Re: **Proposed Development of a Primary Residential Dwelling on Portion 79 of the Farm 205 Ruygte Valley, Sedgefield, Western Cape**

# **VRMA I&AP Response to the Draft Basic Assessment Report for the of a Primary Dwelling and Access Road on Portion 79 of Farm 205, Ruygte Valley, Sedgefield.**

FIGURE 19: ALTERNATIVE 2 SDP

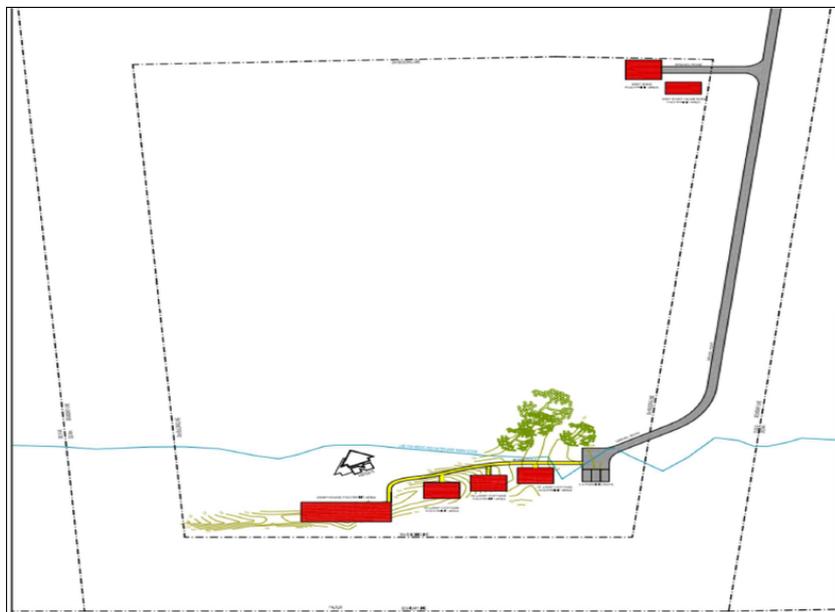
Alternative 2 includes one primary dwelling (400m<sup>2</sup>), three cottages each 80m<sup>2</sup>, a boardwalk, six parking bays, an 80m<sup>2</sup> shed and a 50m<sup>2</sup> cottage. Refer to Extract below, pg. 62 of DBAR.

The application has not included a further viable Alternative of clustering all buildings further to the north-east of the property, adjacent to the entrance to the property off the main access road. This option would provide a more desirable clustered approach which would minimise landscape fragmentation. There is already some disturbance in this area. This siting is further situated away from the sensitive foredune. The landowner could perhaps offer hiking trails through the property leading to a small viewing deck on the foredune. However, it is recommended that no permanent structures should be constructed in this sensitive foredune area.

SANParks will however support an Alternative of clustering all buildings further to the north-east of the property, adjacent to the entrance to the property off the main access road. This option would provide a more desirable clustered approach which would minimise landscape fragmentation, and disturbance to the foredune.

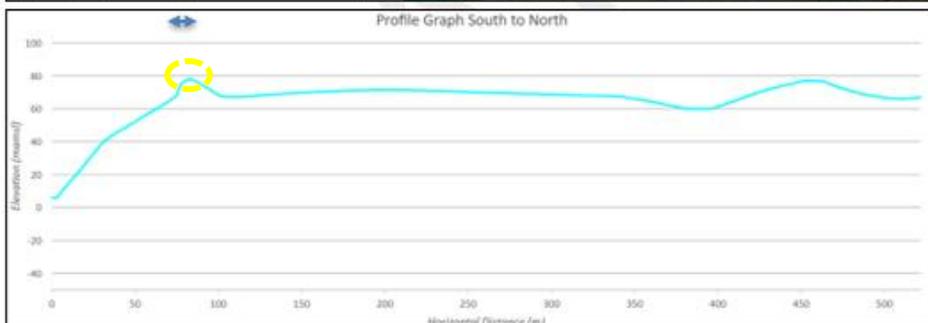
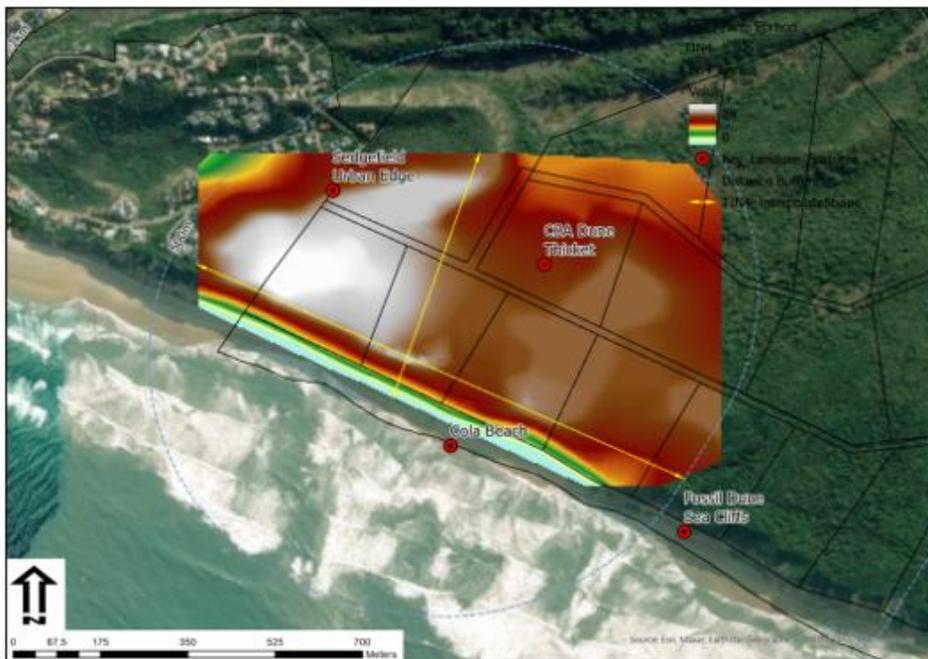
On Page 110, in reply to the VRMA I&AP comment, the following is highlighted:

- Lies inland from the coastal cliff, approximately 700 m east of Cola Beach,
- Occupies stabilised consolidated dunes at elevations of 65–75 m above sea level,
- Is covered by dense Goukamma Strandveld and coastal thicket vegetation,
- Has no direct visual exposure to Groenvlei Beach or the N2, and
- Lies behind the dune ridge, not on an active cliff edge.

The actual development footprint, covering  $\pm 1\,175\text{ m}^2$  (0.02% of the property), will be screened by vegetation and topography, and will not result in skyline intrusion or beach visibility.

FIGURE 17: PREFERRED SDP

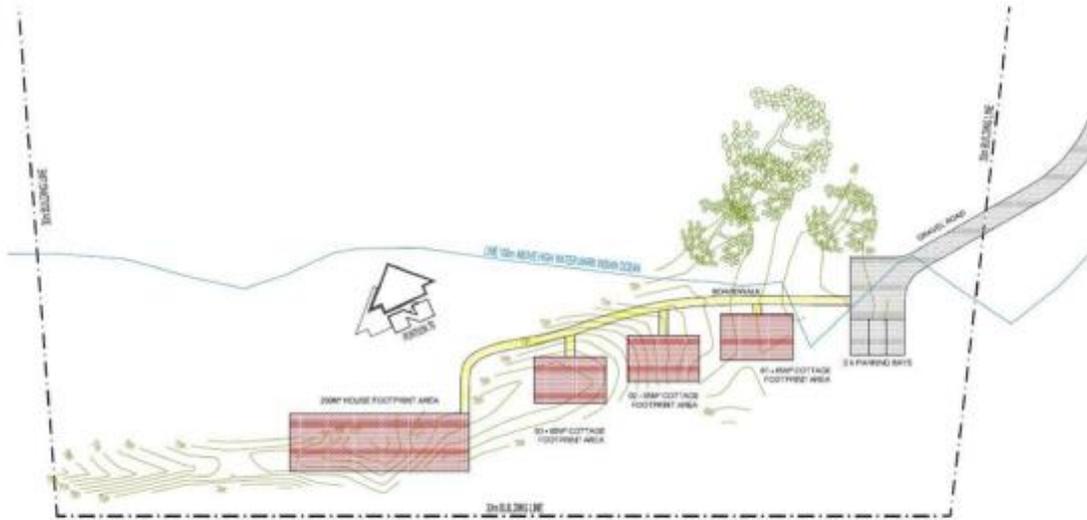
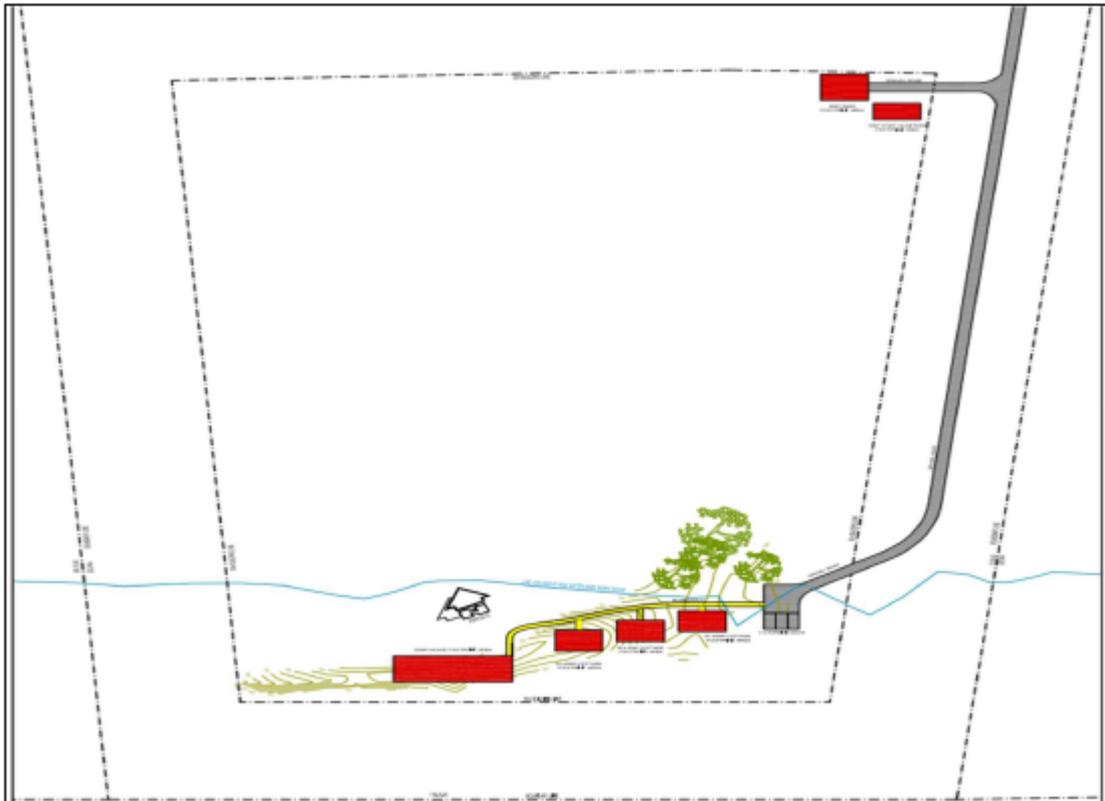
This appears to be incorrect as a review of the layout (following page) finds that they are essentially the same but the Alternative Layout manipulated (reduced vertically) to appear different. The preferred layout still depicts intrusion into the northwest steep slopes area that were not included in the survey. There is also no depiction of a deck (sea facing) on the layout plan.

58. This accords with the applicant's other reports, for instance see Figure 12 at Page 25 of Appendix D4 Terrestrial Biodiversity Assessment:

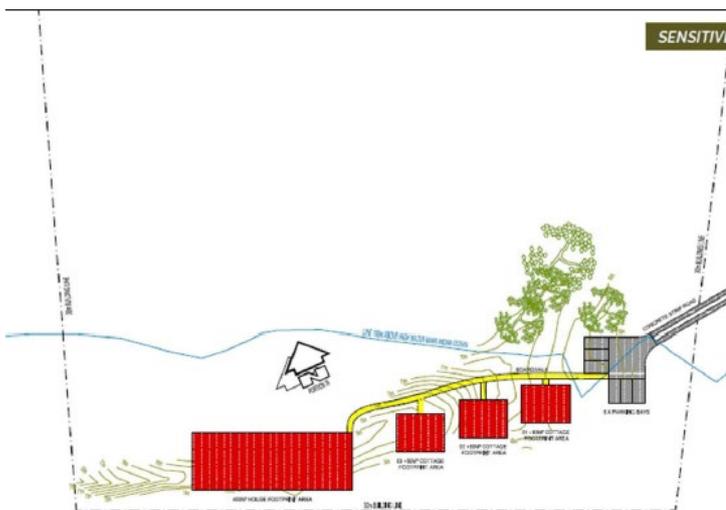
57. Note the form/shape of the property marked with the blue arrow. It is the same property marked in red The locality map, Appendix A1. See too figure 9 on page 21 of the first report, it reflects that the property is adjacent to undeveloped land, with exactly the same features as the property on which the second report was prepared. (This figure is useful as it shows contour lines.) Note the form of the property, the set back on the property to its eastern boundary, and the layout that follows the same contours as the one used in the second report.
